Tasman Resource Management Plan

Plan Change 72: Moorings and Coastal Structures

Report prepared to fulfil the requirements of Section 42A of the Resource Management Act 1991

Map 180F - Milnthorpe

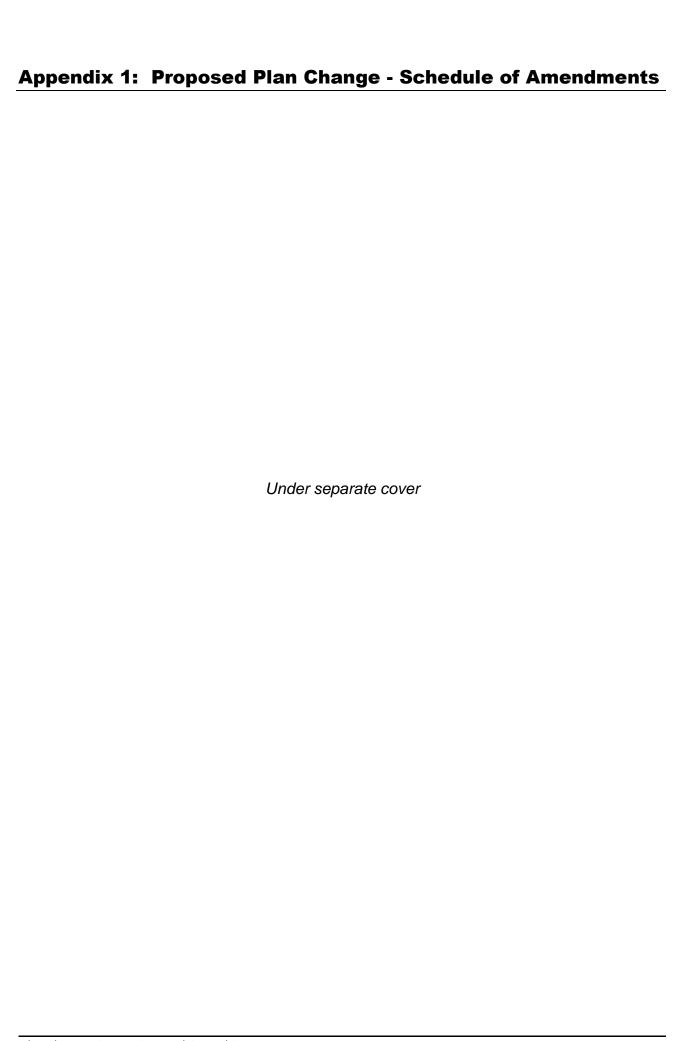
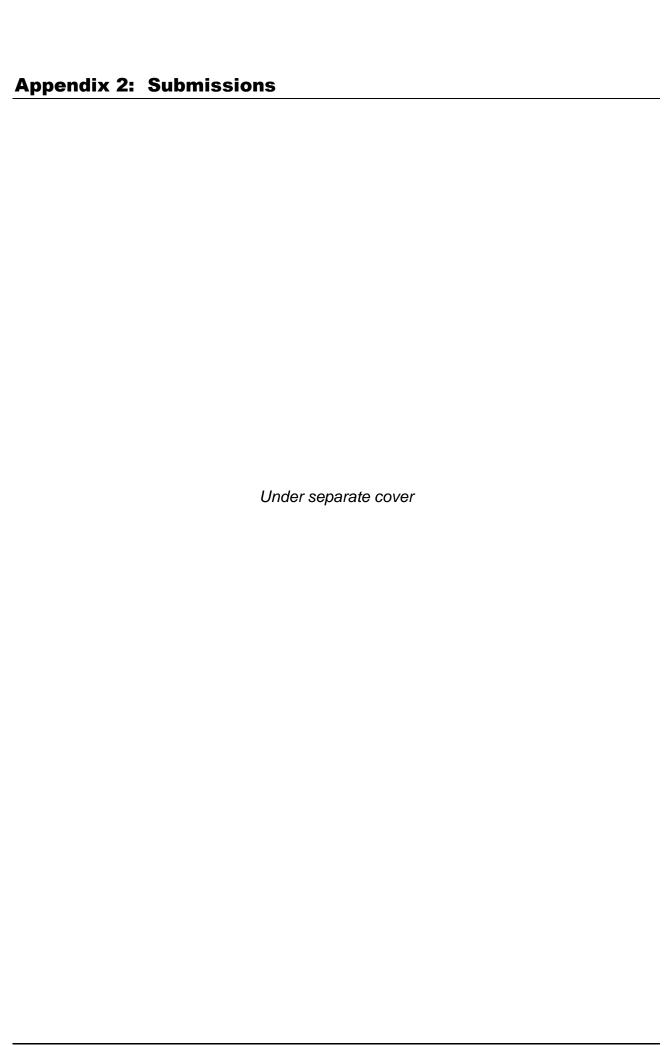
(4171.3) requests the proposed Mooring Area be enlarged back to the size of the original proposal." **Reason:** The Harbourmaster did not identify any issues with original area, more than adequate space, other basins clear of the main tidal flow where visiting vessels can manoeuvre or moor"

Initially the area proposed for the Milnthorpe Mooring Area was extended to incorporate an illegal mooring to the west. Feedback on the extended areas was that the illegal mooring was no longer in use and the proposed area was likely to interfere with navigational passage. For that reason, the Mooring Area was reduced in size. The area is little used for mooring and it is not anticipated that the area will become heavily used following the introduction of the Mooring Area. Should demand increase for moorings within the Milnthorpe then there is the opportunity through the plan review to expand the Mooring Area pending further investigation.

Recommendation: No change.
